Please find enclosed a revised version of our manuscript for submission to Cryosphere. All the comments made by the referees have been accounted for as discussed below. A manuscript with the changes overlaid is also provided.

1. The Referee wrote *“Review of the manuscript entitled: “Rockwall permafrost dynamics evidenced by Repeated and Automated Electrical Resistivity Tomography at Aiguille du Midi (3842 m a.s.l., French Alps)”*. This manuscript reports the use of an automated system capable of recording periodic electrical resistivity tomography profiles over a permafrost dominated high altitude site in the French Alps. As much as I admire the authors for being able to instrument such a challenging site, and despite slight improvements from the previous iteration, the manuscript requires a thorough revision and potential reorganisation of scope and narrative. A few major issues prohibit me from recommending it for publication: There is a certain ambiguity around the methods used in this work. Authors need to be clearer and add more details about methods around field water sampling, laboratory complex impedance measurements, electrical resistivity data processing pre and post ge

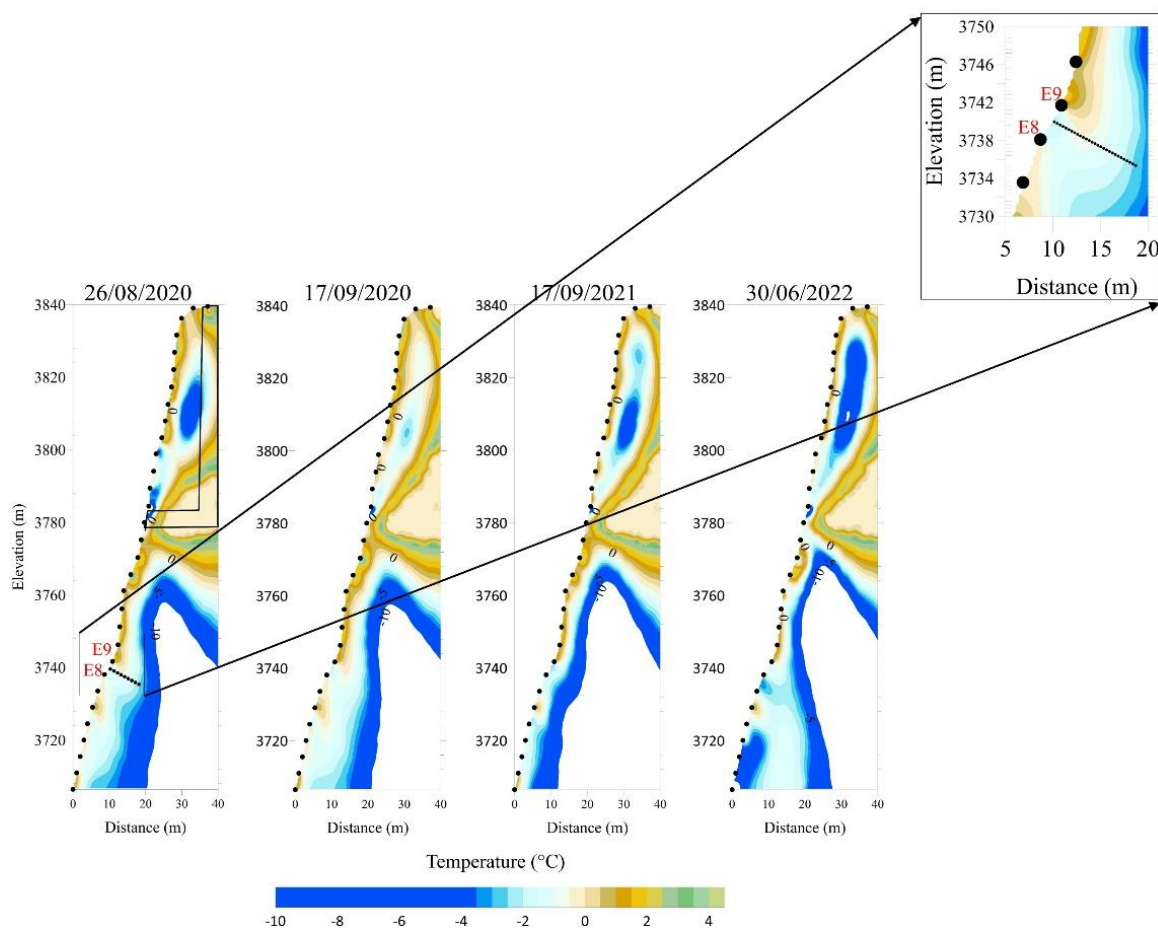
4. The Referee wrote “*On a previous round of revisions, the novelty of this manuscript was put under scrutiny. And I would agree, A-ERT alone is not novel for the study of permafrost stability. However, I see a lot of value and potential fruitful discussions in aligning temperature datasets derived from geophysical measurements with temperature datasets measured in boreholes (as was done for Figure 10). I also like the idea of having pseudo boreholes to compare temperature variability with depth at different locations along the profiles. If you have a good resistivity-temperature conversion model, why not present a series of 2D temperature profiles corresponding to the different timesteps?*”

**Response:** We agree and the change has been done accordingly. We thank the reviewer for this insightful and constructive suggestion. We agree that aligning temperature datasets derived from geophysical measurements with borehole observations provides valuable insights, and we appreciate the positive feedback regarding Figure 10 and the pseudo-borehole approach. While it is technically feasible to generate a full series of 2D temperature sections from the resistivity–temperature conversion, we included in the revised version of the manuscript. Nevertheless, in response to the reviewer’s suggestion, we now provide a representative 2D temperature section corresponding to the dataset presented in the Temperature–Resistivity conversion section.

**Figure 2:** schematic of the sample holder, the bath, and the impedance meter used for the laboratory electrical resistivity measurements.

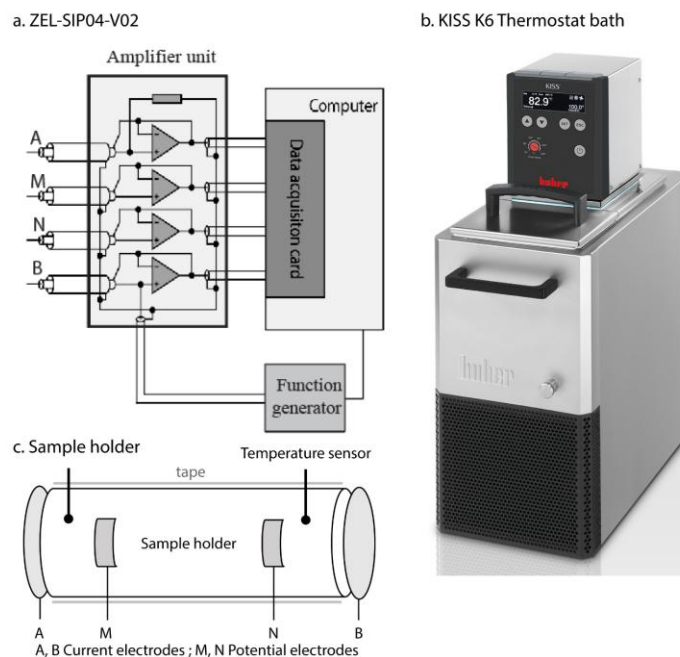
23. The Referee wrote “*Figure 3: Do you happen to have a photo/schematic of the lab setup? It would help a lot to understand your experiment.*” **Response:** Here is a photo of the experimental setup (from our previous work, Coperey et al., 2019). The sample was placed in the bath, and the electrodes were connected to the impedance meter for the measurements. To avoid increasing the number of figures which is already high this figure will not be included in the manuscript.

**Figure 3:** Photo of the jumper used to attached electrodes and take-out.

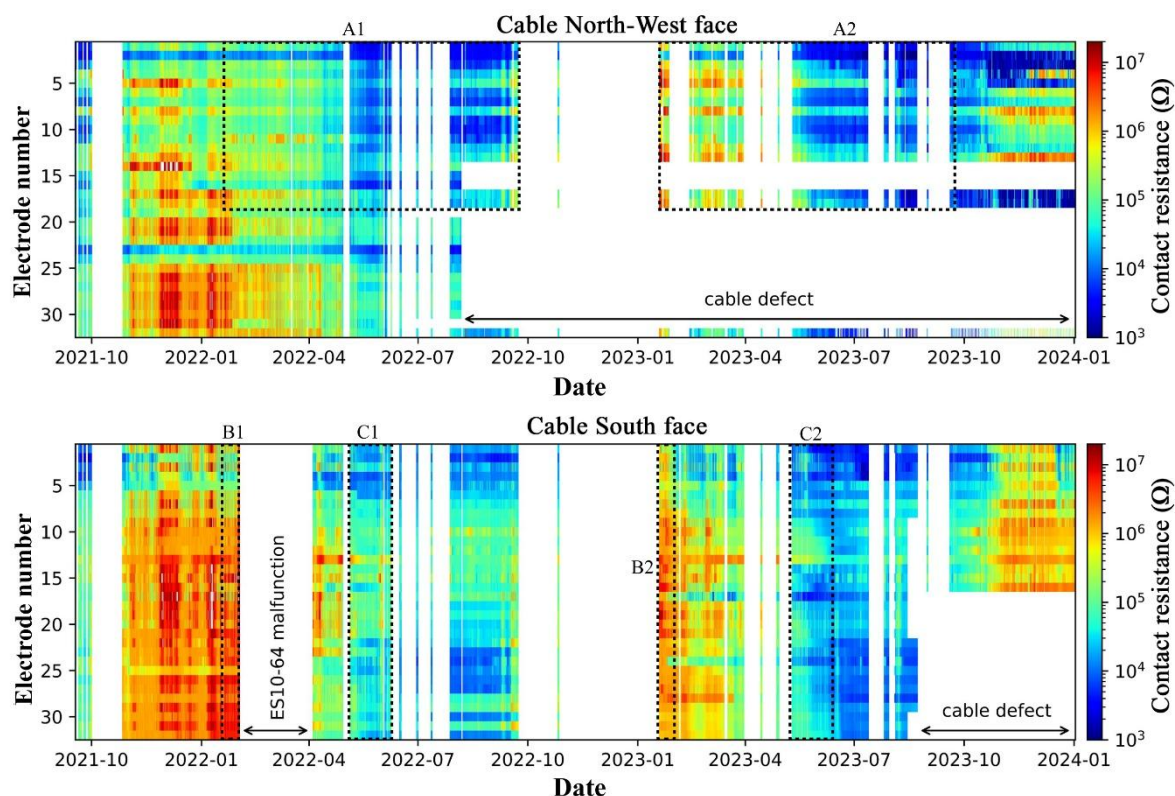
27. Line 258: Again, it would be very valuable if you had a photo. Do you mean “jumper cable”?” **Response:** Yes, we used a jumper cable to fix the cable at each take-out. A photo of the specially designed stainless-steel jumper used to attach the cable takeout to the climbing bolt is available (a duplicated electrode is shown in the photo to ensure improved electrical contact). However, in order to keep the number of figures in the manuscript reasonable, we have chosen not to include this image.
